**TOWN OF BELLEAIR
BUILDING DEPARTMENT**
901 Ponce de Leon Blvd.
Belleair, Florida 33756-1096
Phone: (727) 588-3769 ext. 215
Fax: (727) 588-3768

SUBJECT: Variance Application for:
Daniel Doyle
3 Stonegate Drive
Belleair, Florida 33756

PRIVATE DOCK

SPECIFIC PURPOSE SURVEY
FOR THE PURPOSE OF ACQUIRING A DOCK PERMIT IN FRONT OF LOT # 3, & TRACTS 'B' & 'C' # 3 STONEGATE DRIVE, BELLAIR, FLORIDA

Plan View
(applicant and adjacent docks)

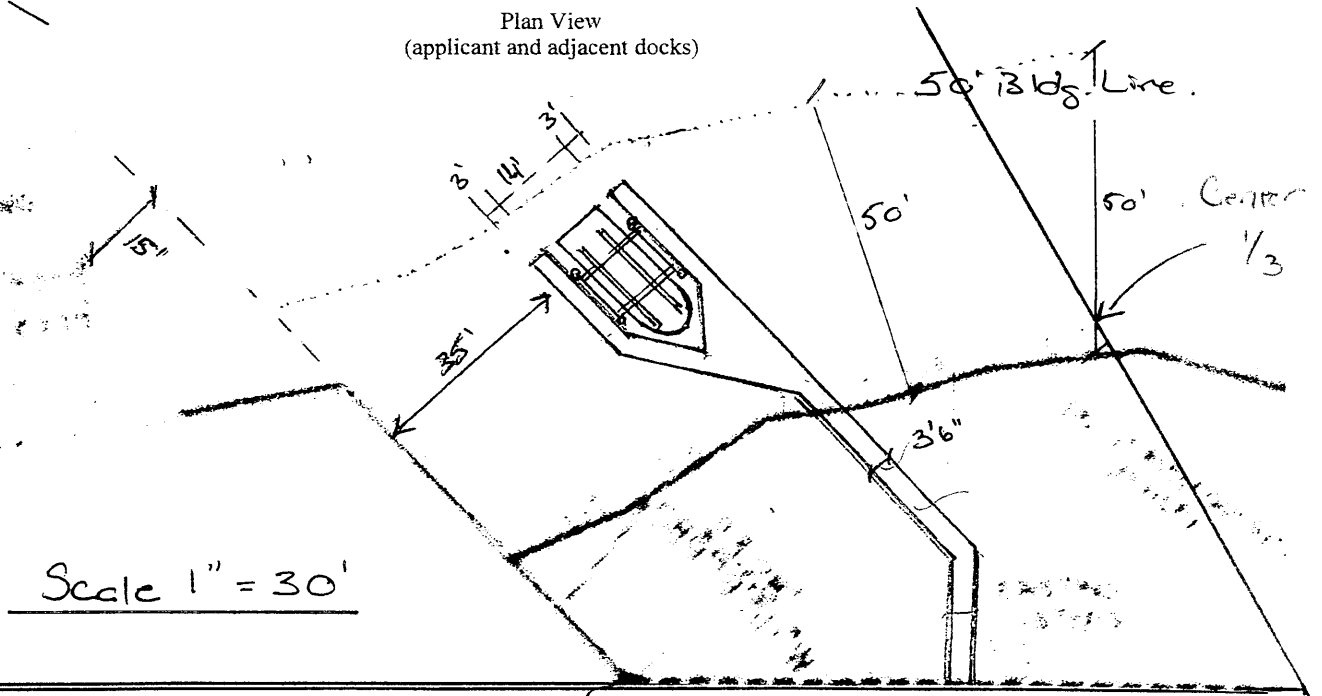
- **Need a letter of acceptance by Stonegate Homeowners Association.**
- **Catwalk must be 3ft per town code not 3'6" as indicated on plan, need to apply for additional variance or redesign catwalk.**
- **Dock is outside of the 50' ft measurement from waterfront that is allowed per town code, please indicate how long dock is per site plan and re-submit for variance. Dock is measured from seawall not property line as indicated per variance request.**
- **11/14/2016 Planning and Zoning meeting has been cancelled, as well as the commission meeting scheduled for 11/15/16. The town will need clarification regarding these matters before proceeding with variance.**

Per our conversation this morning, it is my interpretation that the measurement is taken perpendicular from the upland portion of the property (where the dock connects to the seawall), and not from the seaward extent of the submerged lot.
